**IMPERIAL METALS CORPORATION  
MT. POLLEY PROJECT**

**RESPONSE TO REVIEW COMMENTS  
ON TAILINGS EMBANKMENT DESIGN  
(REF. NO. 1625/6)**

**JANUARY 25, 1996**

PROJECT : MT. POLLEY TAILINGS GRADATION

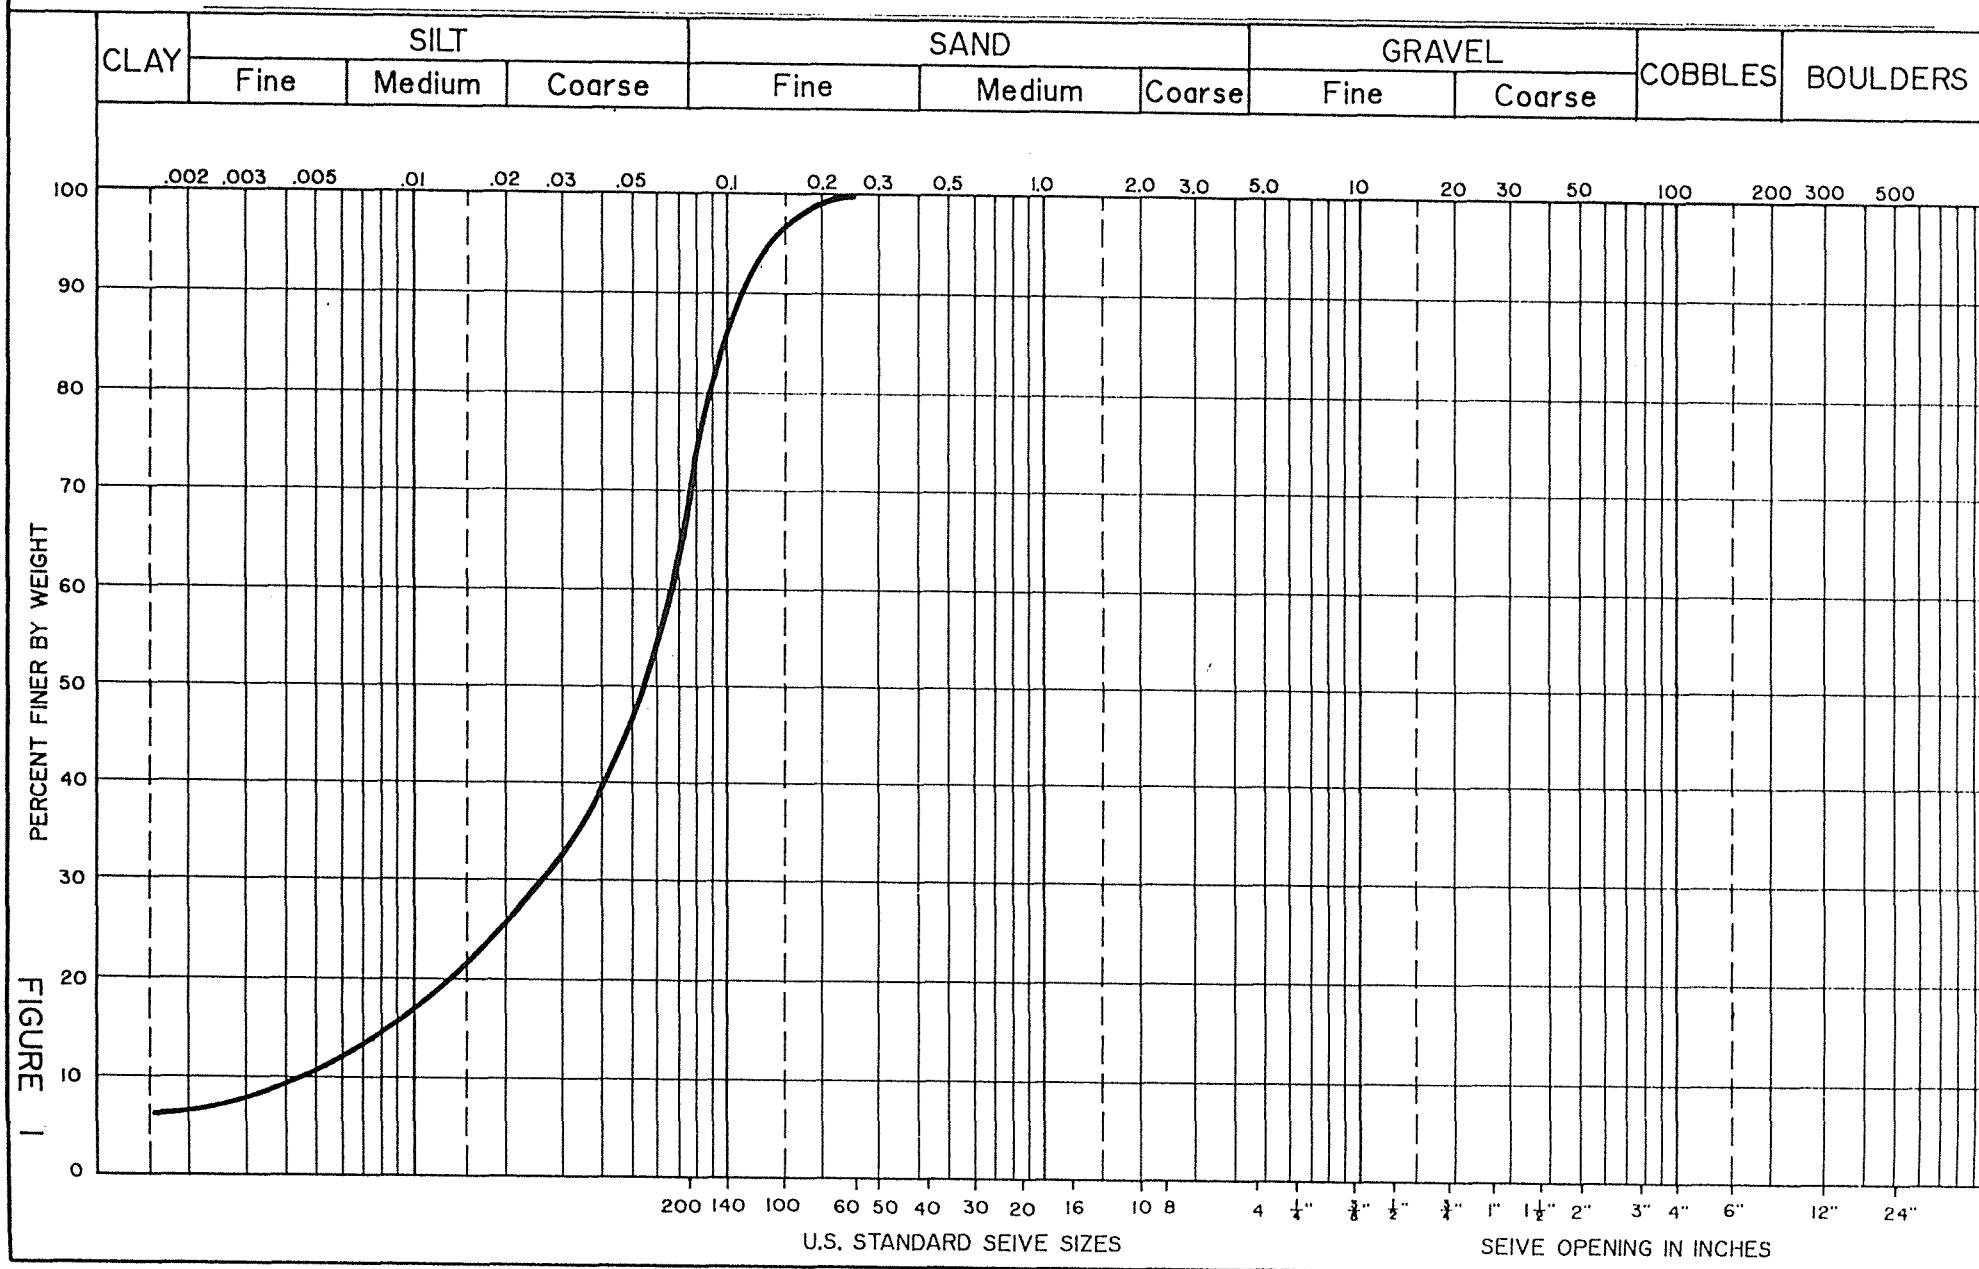
***Filter gradation is required to be shown. The design must be conservative.***

Filter gradations for construction materials are shown on Drawing No. 510-14-03-1625.212, which is taken from part of the Technical Specifications. The gradation of the tailings is shown on Figure 1 (from Tailings Storage Facility Design Report, Ref. No. 1625/1, May 26, 1995).

The filter materials are considered to be ‘non-critical’ as defined by Sherard et al (Sherard, J.L., Dunnigan, L.P. and Talbot, J.R., 1984. “Filters For Silts and Clays”, ASCE Journal of Geotechnical Engineering, Vol. 110, No. GT6), as they are situated upstream of the core zone. However, the specified filter gradations have been conservatively designed to meet the more rigorous criteria for ‘critical’ filters. Therefore, the specified filter gradations meet or exceed conventional filter requirements for both the glacial till core zone and for the tailings solids.

Index tests on the bulk tailings sample shown on Figure 1 indicate that the material is non-plastic and fine grained, with 6 percent clay, 64 percent silt and 30 percent fine sand. The operations of the tailings spigotting system will lead to some separation of the tailings adjacent to the embankment, whereby coarser materials will settle out rapidly and finer materials will be transported further out into the pond. The result is that additional filter relationships will be developed between the fine and coarse tailings as well as between the coarser tailings and embankment fill materials. In the event that cracks develop on the embankment from the upstream side, it is anticipated that the tailings will also function as a crack stopping filter medium.

RELATIONSHIP BETWEEN COMPACTION ENERGY AND MOISTURE CONTENT - DENSITY  
(CHARACTERISTIC COMPACTION CURVES FOR GLACIAL TILL)

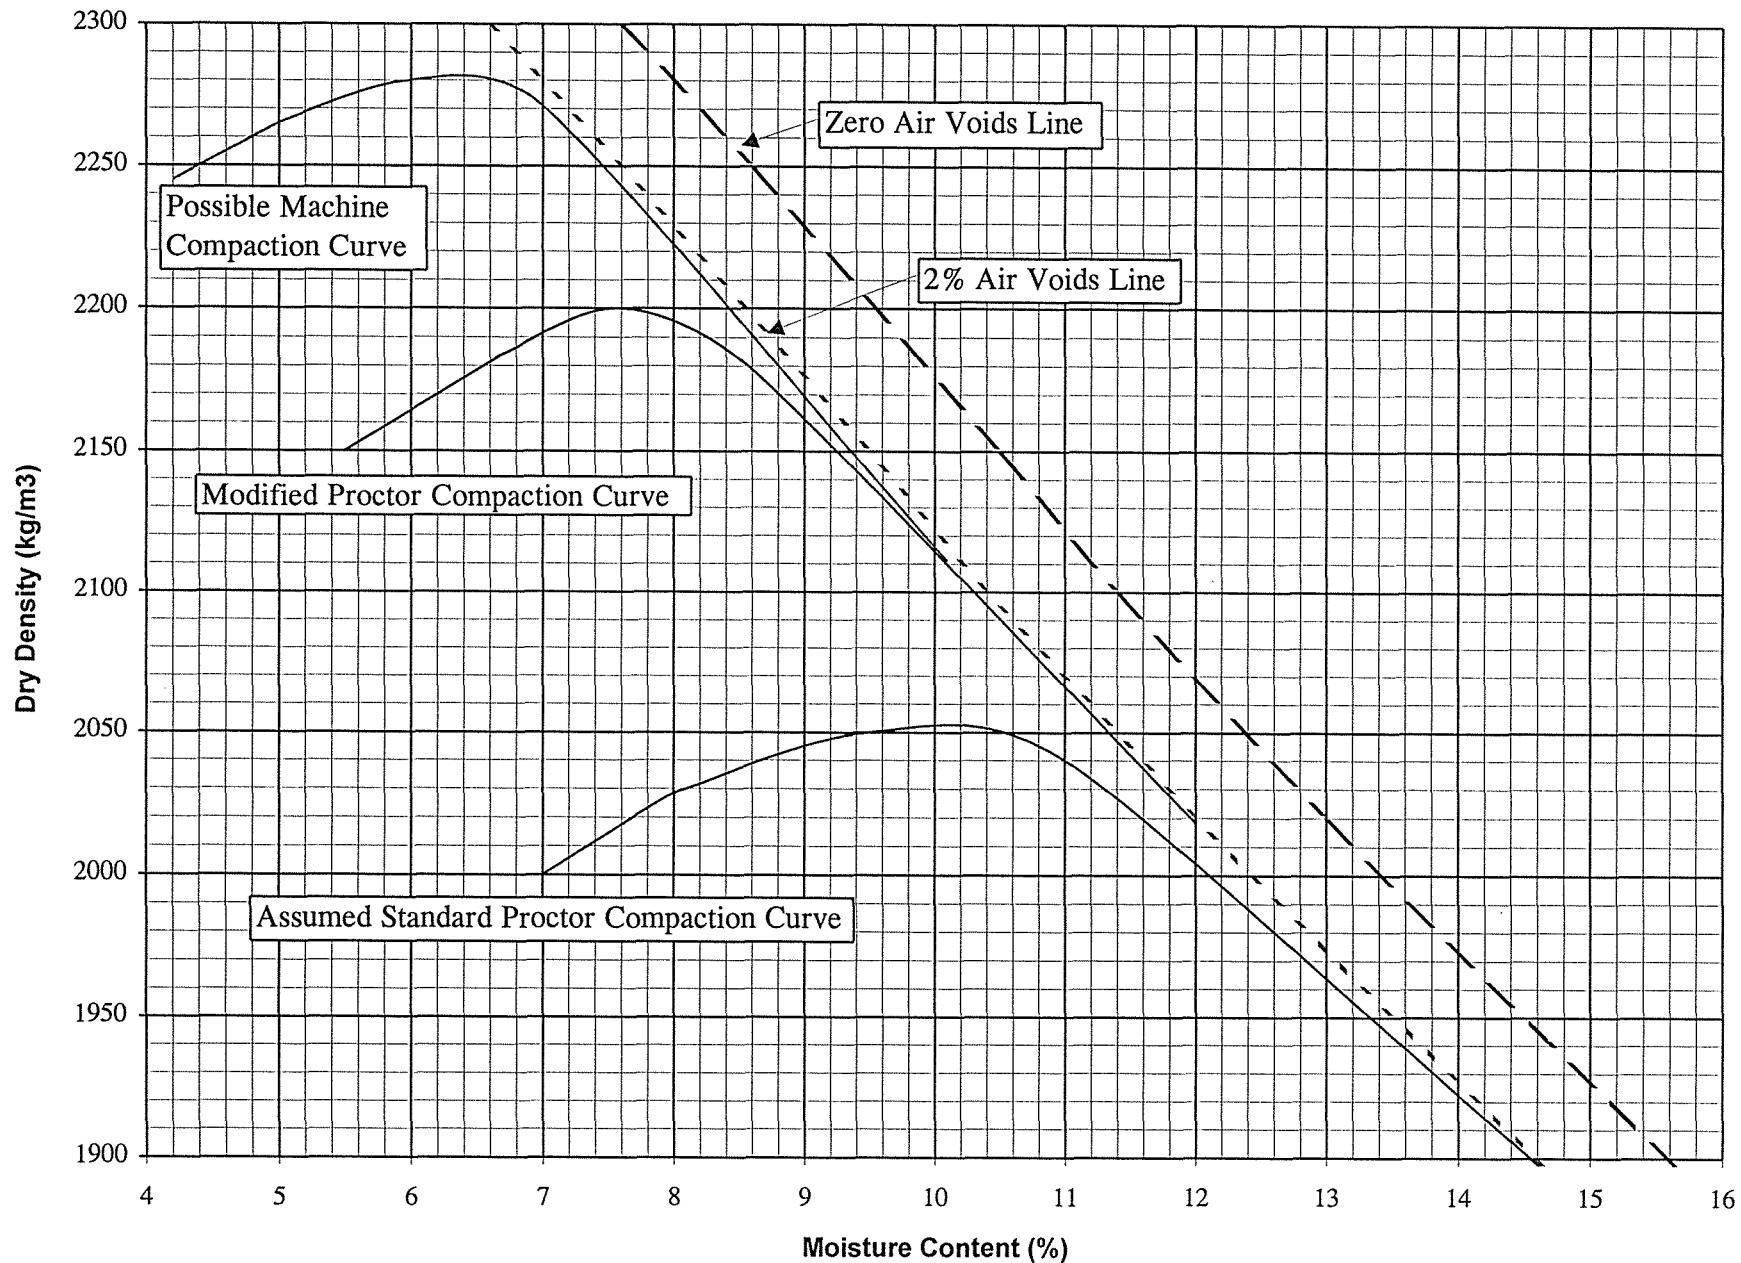
*Why is Modified Proctor density used as the reference? Standard Proctor density is more common. A higher moisture content can be tolerated with Standard Proctor criteria. Over-compaction results in a brittle dam structure with limited flexibility to deal with differential settlement.*

Mr. Brawner's statements reflect a common misconception within the earthworks construction industry. As indicated on Figure 1, there are different moisture-density relationships depending on the level of compactive effort applied. The Standard Proctor energy is lower than for the Modified Proctor test and, for the given example, the machine compaction energy is still higher.

It is evident from Figure 2 that if one only considers the individual test results, the 'maximum' density decreases as the compaction effort is reduced, and the 'optimum' moisture content also increases as the compactive effort is reduced. However, the theoretical moisture content - density relationship for a soil is defined by the zero air voids line, but we generally find that the 2% air voids line is usually the control in practice. Consequently, if the Standard Proctor moisture density criteria are

specified, a lower density fill with a higher permeability and greater compressibility can result. Also, if the contractor attempts to place the fill at the standard proctor optimum moisture content with the heavier compaction equipment, he will sometimes find that excessive rutting, weaving and pore pressure development (or moisture profiles) can occur in fine grained soils. Knight Piésold have therefore used the Modified Proctor test as the reference as it provides a moisture - density relationship which is closer to the relationship expected from the specified compaction equipment.

The glacial till has a fairly low plasticity (PI = 10 to 14) and will be placed at near the optimum moisture content as defined by the Modified Proctor test. Placement at a higher moisture content and a lower density as suggested by Mr. Brawner would result in larger post construction fill settlements and would increase the likelihood of cracks forming in the fill.
